RS-03-163

Quad Cities Nuclear Power Station, Units 1 and 2
Facility Operating License Nos. DPR-29 and DPR-30
NRC Docket Nos. 50-254 and 50-265

Subject: Response to Request for Additional Information Regarding the Quad Cities Nuclear Power Station, Units 1 and 2, Fourth Interval Inservice Inspection Program Plan

Relief Request Number I4R-05, Revision 1

FIGURE I4R-05.1

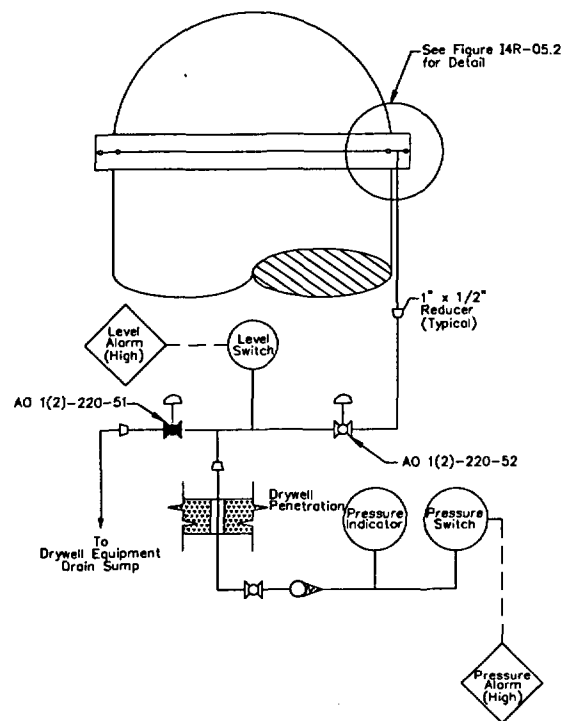
The basis states that the alternative provides an acceptable level of quality and safety, but the majority of the discussion focuses on the difficulty and impracticality of performing the examination by summarizing at the end of your discussion by stating: "It is impractical to purposely fail the inner O-ring in order to perform a test." Please demonstrate why the alternative provides an acceptable level of quality and safety. Secondly, has this configuration been tested in the past, and if so, was it successful or unsuccessful? If it was not tested in the past, has relief previously been granted, and if so, please provide previous relief request information on this weld along with NRC evaluation.

A VT-2 visual examination will be performed on the line during vessel flood-up during a refueling outage. The static head developed due to the water above the vessel flange during flood-up will allow for the detection of any gross indications in the line. This examination will be performed with the frequency specified by Table IWC-2500-1 for a System Leakage Test (once each inspection period).
